Technical Service Bulletin

2071190/3

HVAC failing to cool | DTC B16A1F0 in diagnostic address 00C5 | Bentayga Series (Hybrid) | 23MY - 25MY

Figure 1

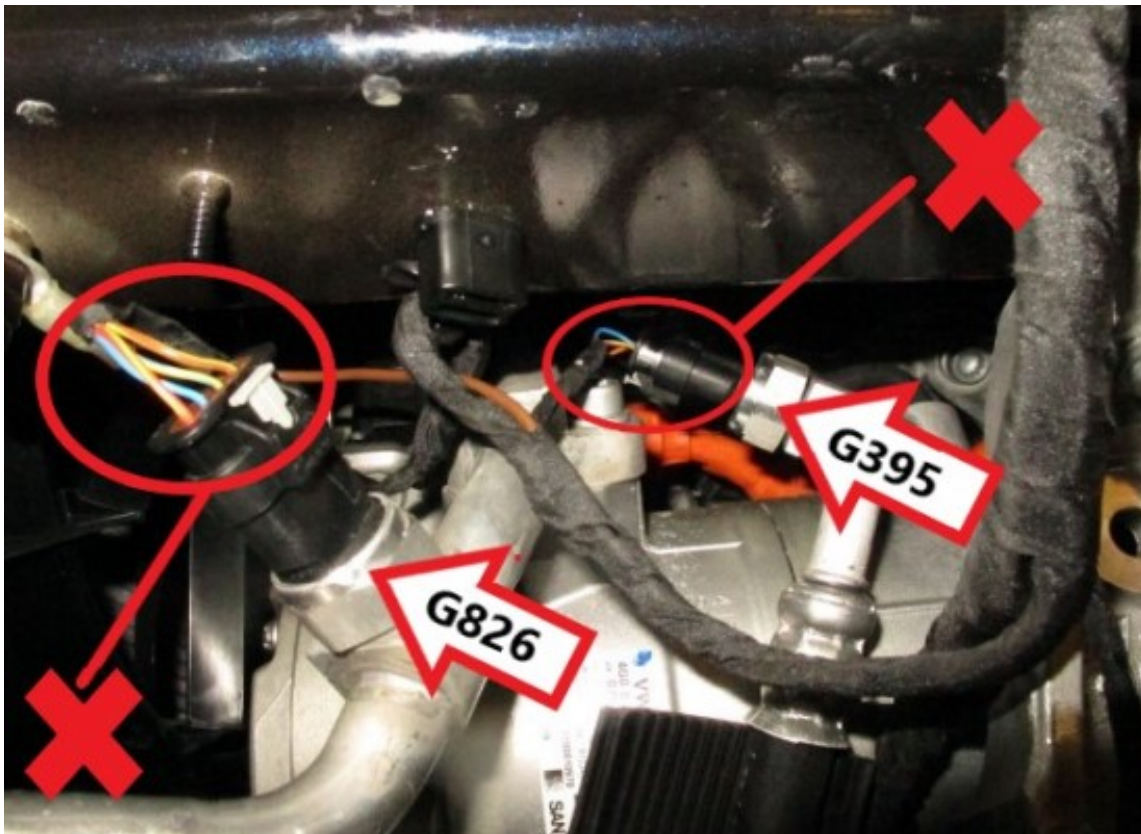
- 1) Referring to Rep.Gr 44 - Remove the left hand front wheel
- 2) Referring to Rep.Gr 66 - Remove the left hand front foremost wheel arch liner
- 3) Remove (x3) speaker box fixings (5Nm)
 - Disconnect the speaker box electrical connector
 - Remove the speaker box
- 4) Access can now be gained to the required connector plugs - Figure 1 shows G826 and G395 with the connector plugs fitted incorrectly
 - Low pressure sender G826 connector plug with 4 wires **(Incorrect)**
 - High pressure sender G395 connector plug with 3 wires **(Incorrect)**

In the event the pressure sender connector plugs are fitted incorrectly the plugs should be disconnected and refitted correctly as shown in Figures 2 and 3

Figure 2

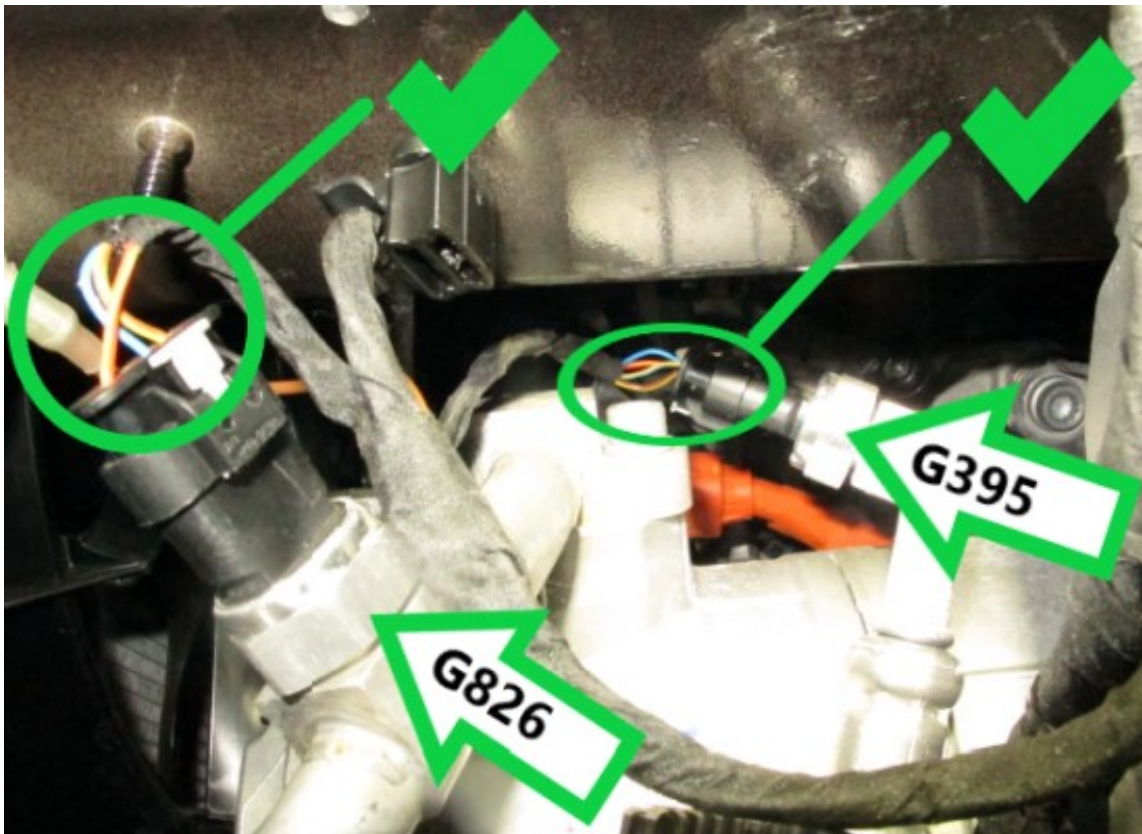
- Figure 2 shows G826 and G395 connector plugs fitted correctly
- Low pressure sender G826 connector plug with 3 wires (Correct)
- High pressure sender G395 connector plug with 4 wires (Correct)

Figure 3

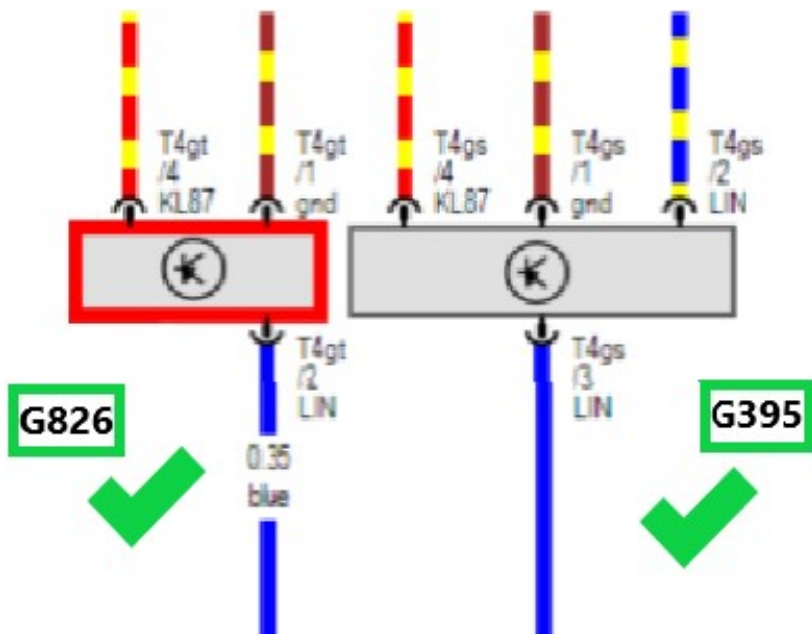
Hint: Figure 3 shows G826 and G395 as per the applicable Current Flow Diagram (Correct)
